File 1994-0189

Name: Country Crossing Subdivision – Preliminary Plan – SE 25 Road / G Road

REQUEST: Preliminary Plan review for 174 residential units and Final Plan/Plat review for Phase I of Country Crossing

EXHIBIT A

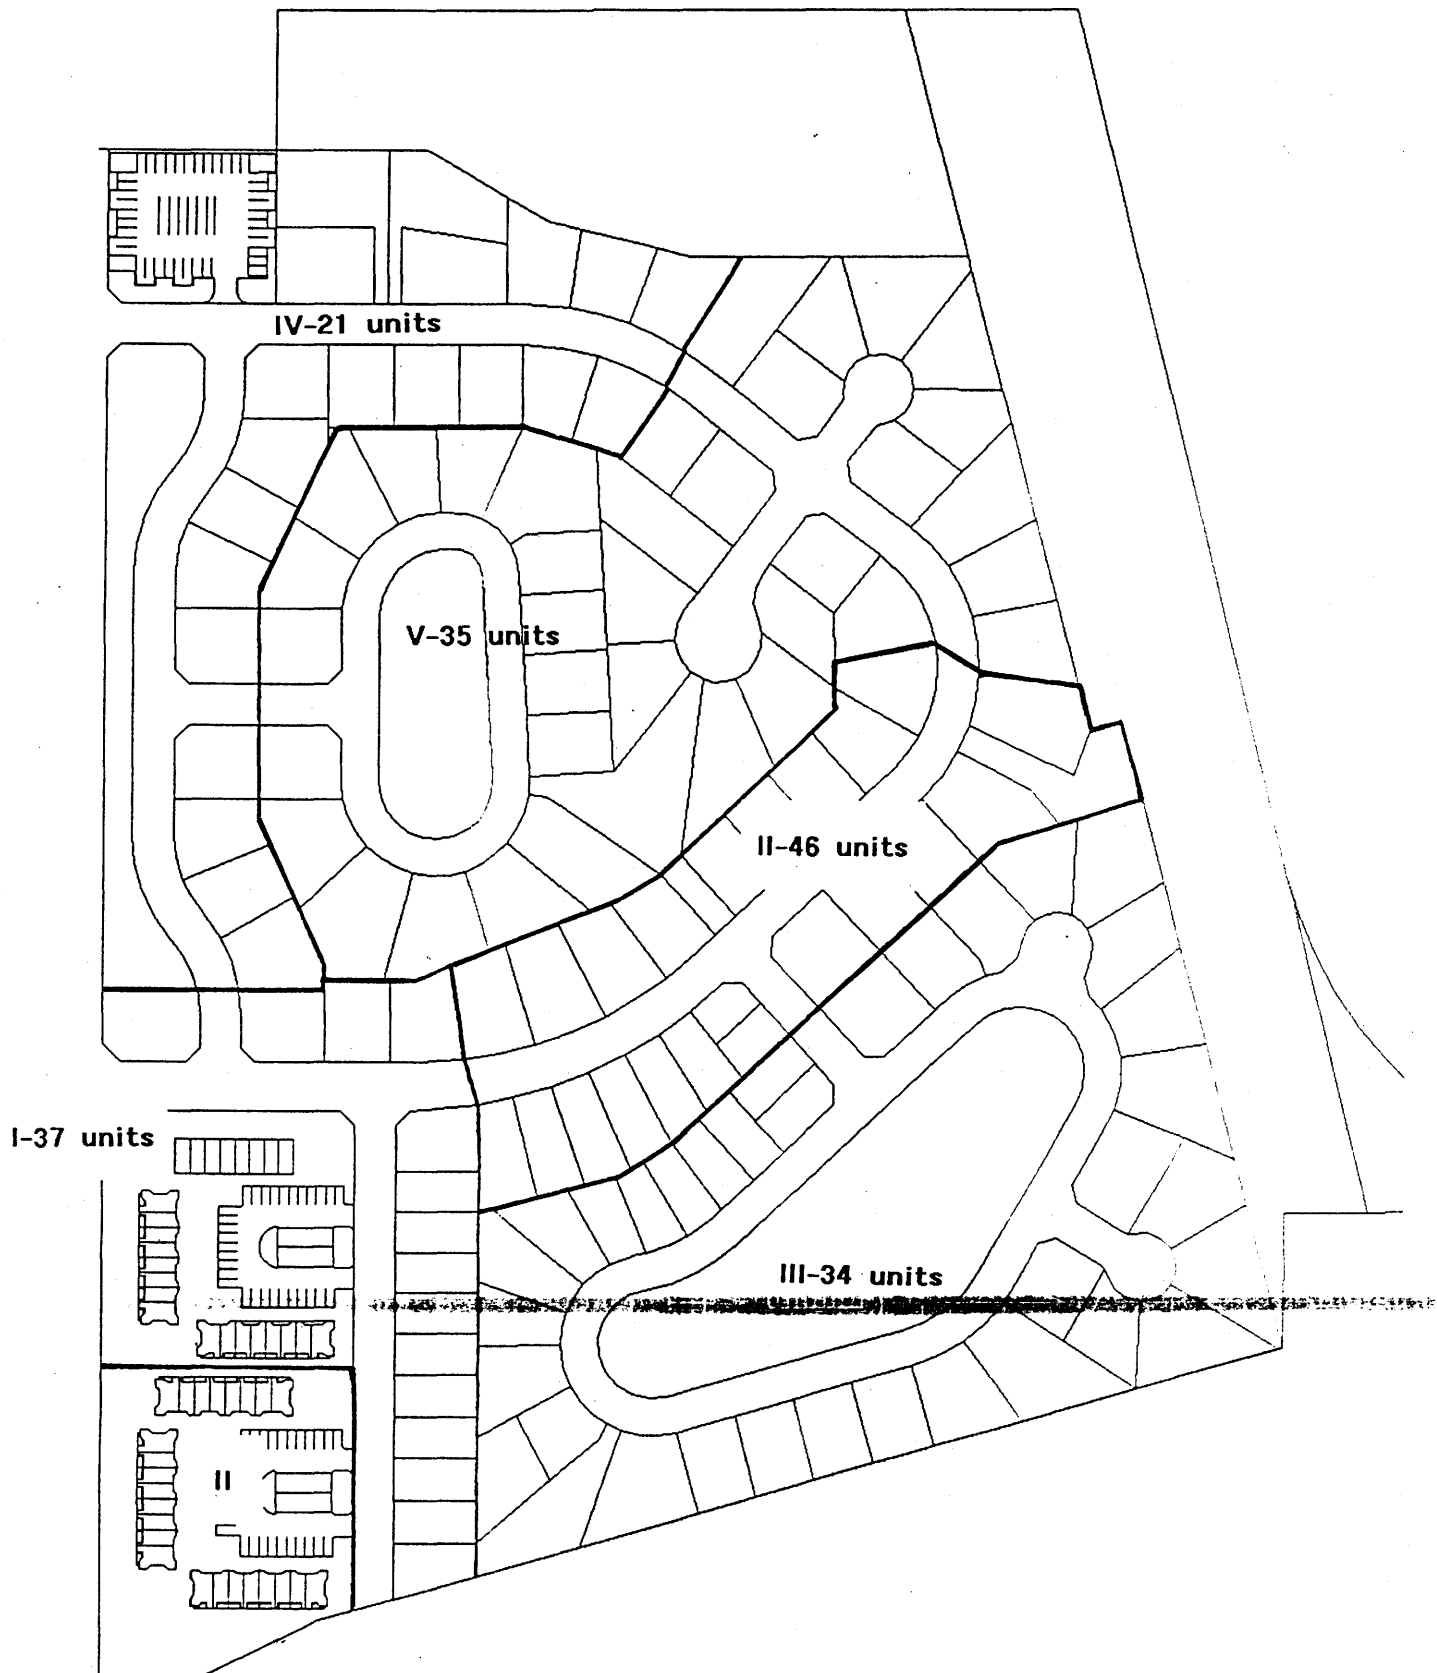
- 8) A maximum of five lots may be approved under preliminary/final plan review as Phase I. Final plans/plat must be submitted in conformance with the Submittal Standards for Improvements and Development (SSID) manual. The platting of all remaining lots will have to be delayed until final plat/plan approval for the entire project.

TOWNHOME DETAIL
SCALE 1" = 50'

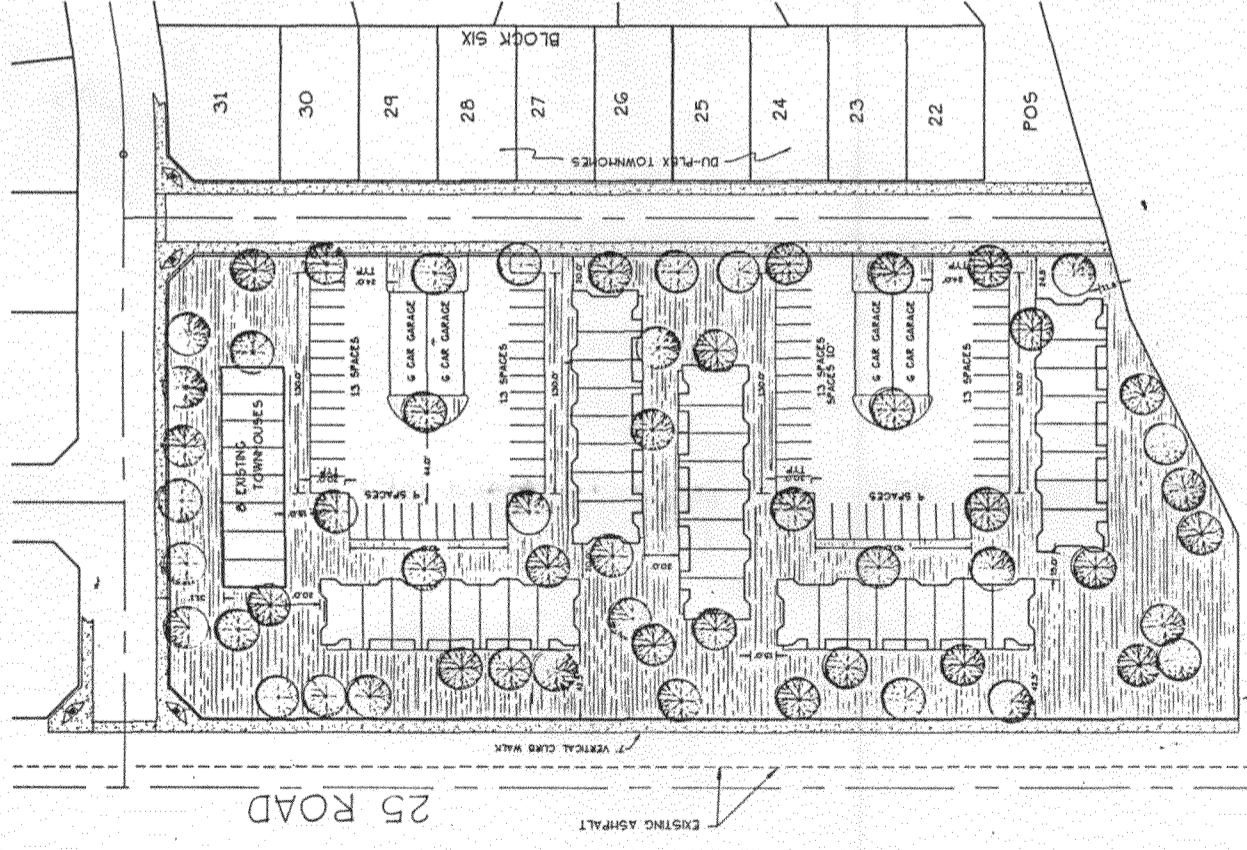
- 6) The townhome detail shows no sidewalk connections between the structures or to the parking lots. These connections need to be shown.
- 7) The trail along the canal will need to be improved with a 10-foot wide concrete path built to City standards.

4. It is the petitioner's desire to transfer ownership of the 5.7 acre parcel along G Road to the City for public use.
5. Preliminary sidewalk connections have been added to the site plan for the multi-family area.
